**Re: AVANYU RETAIL/ for building D, E, and F**  
**2400 12<sup>TH</sup> ST. NW**  
**30-Day Temporary Certificate of Occupancy**  
**Transportation Development Final Inspection**  
Engineer's Stamp dated 3-14-22 (H13-D113)  
Certification dated 3-2-22

**AVANYU RETAIL**

**SITE PLAN FOR BUILDING PERMIT**

**AS-101**

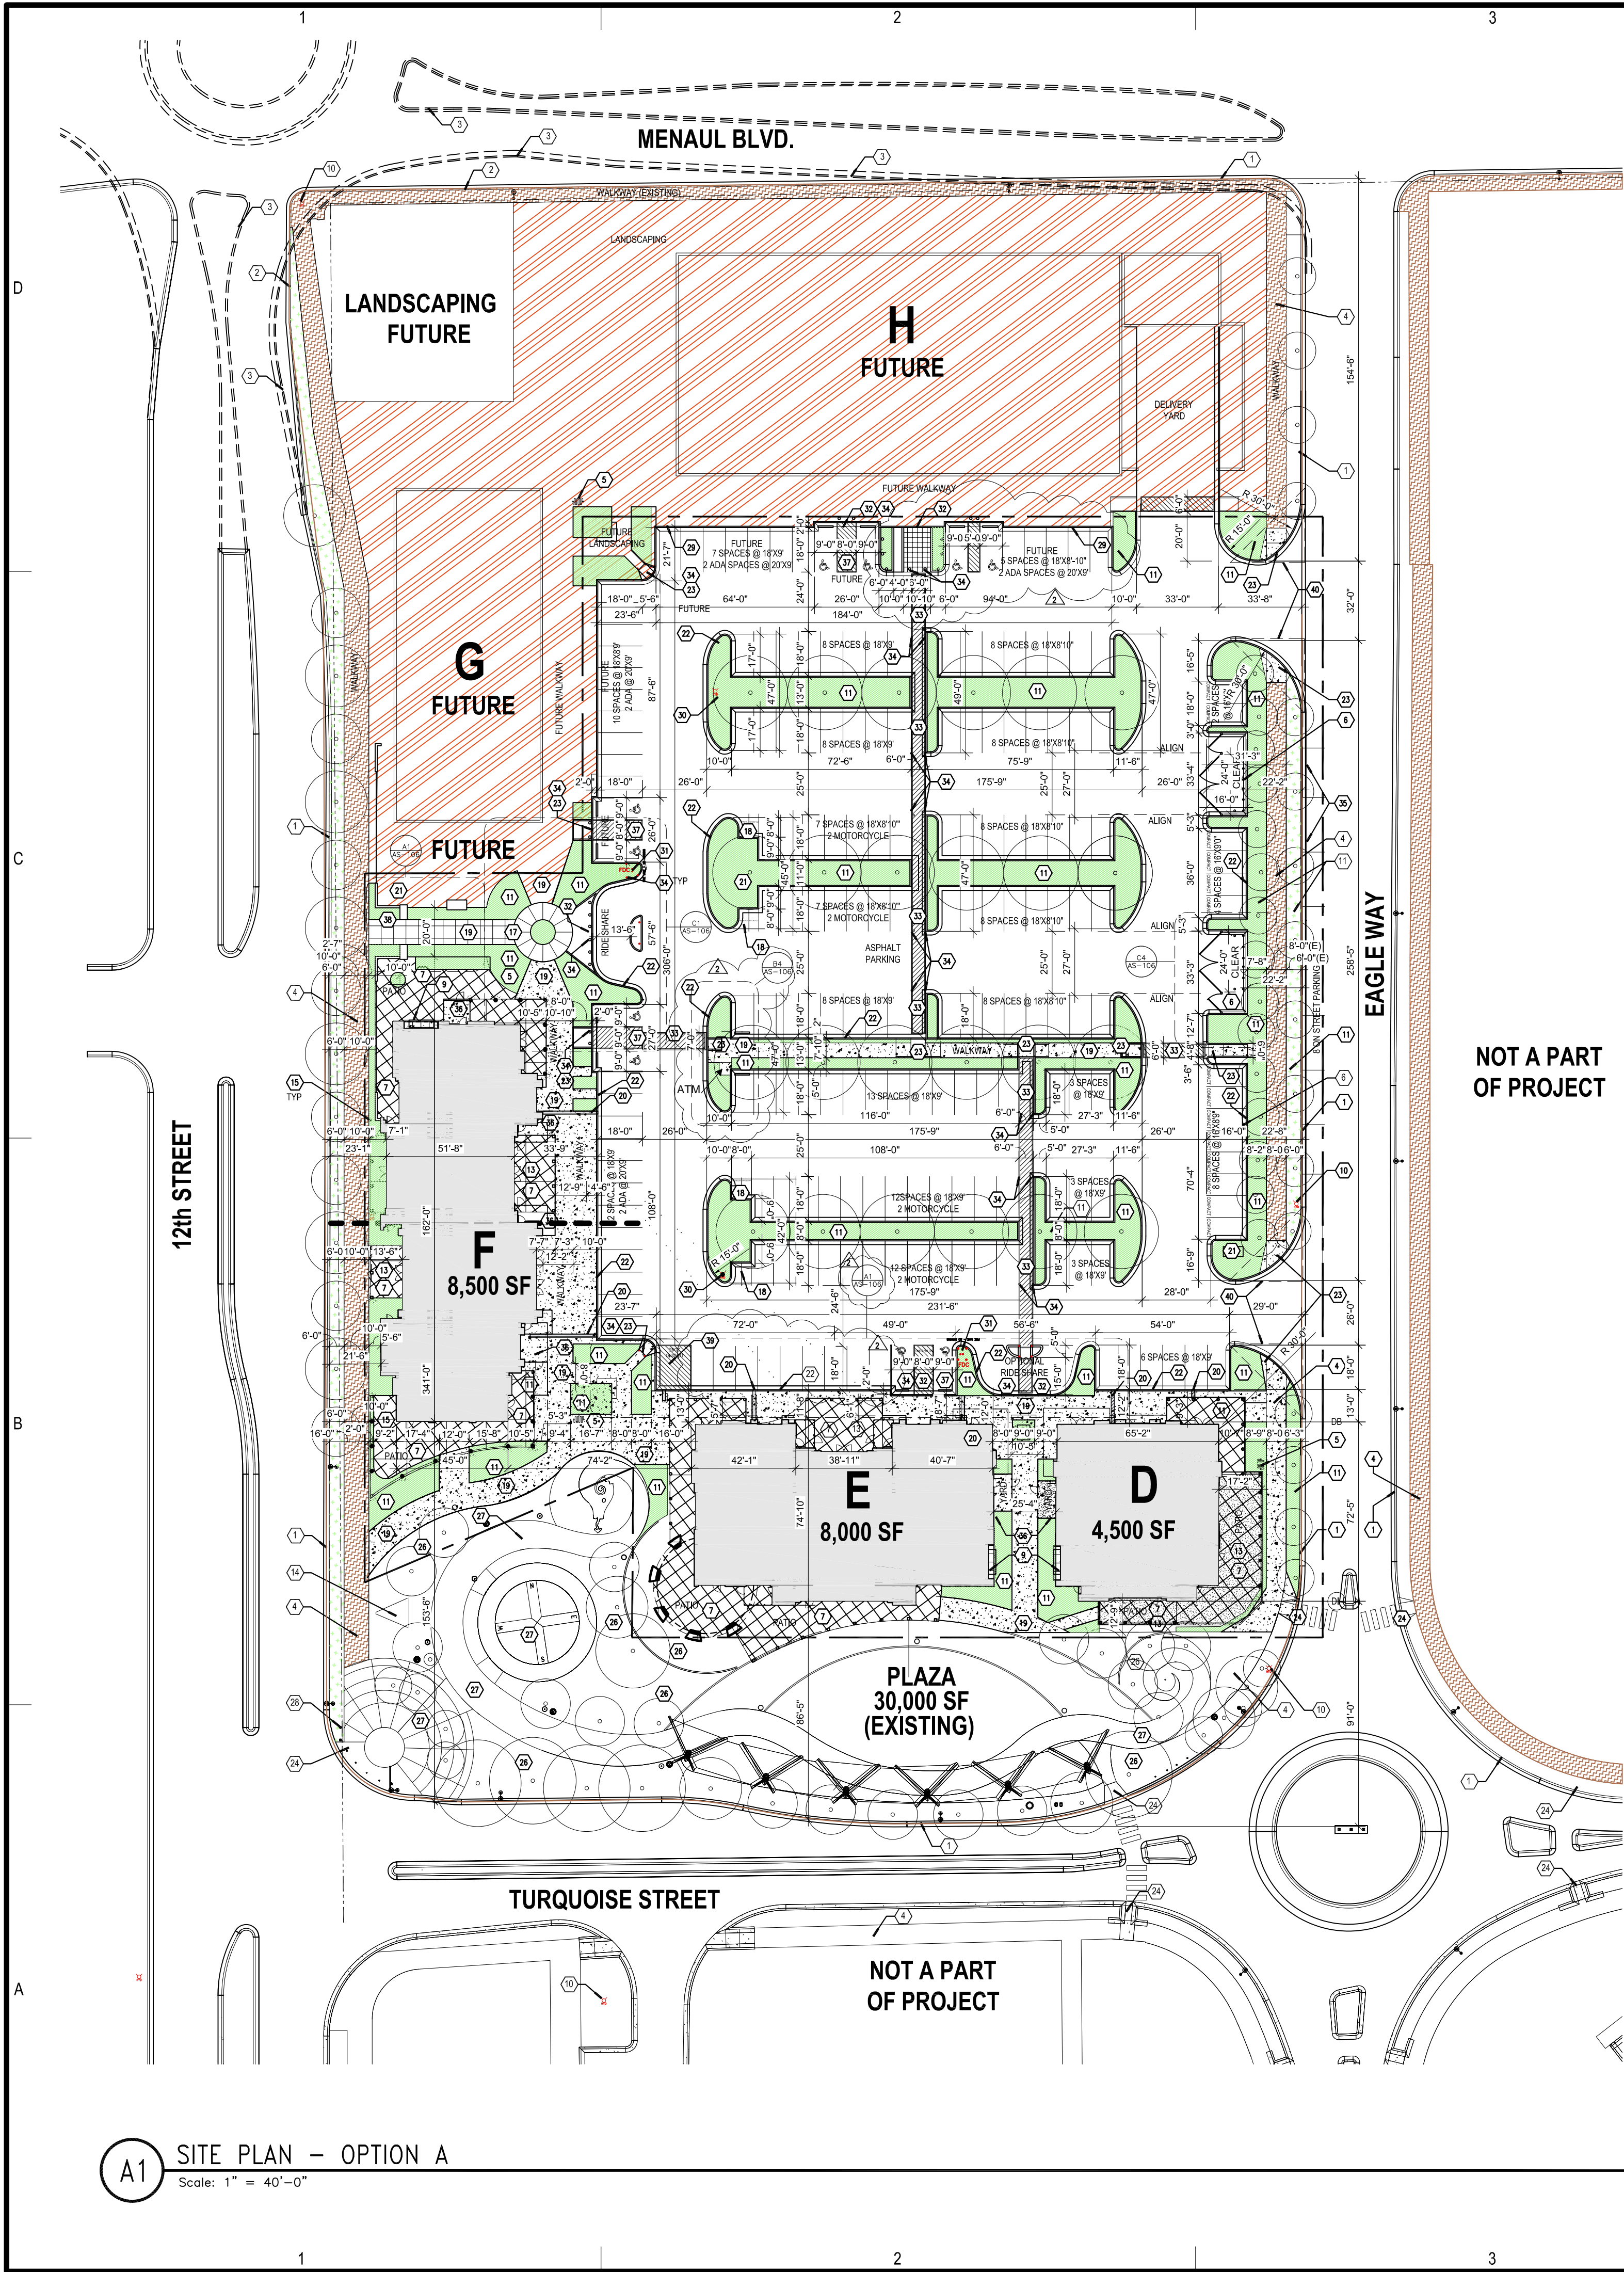
- Provide adequate Bicycle Racks per the approved site plan.
- Label the compact parking spaces by placing the words "**COMPACT**" on the pavement of each space.
- Key note23: At the northeast side of the site, ADA Ramp needs to be scraped to be flush with the ground.
- Key note4: sidewalk at the east side of building H has not been built per the approved site plan. Please address this concern.
- Provide 8 on-street parking spaces per approved site plan. Please remove the first on-street parking space that close to the driveway entrance for clear sight issue.
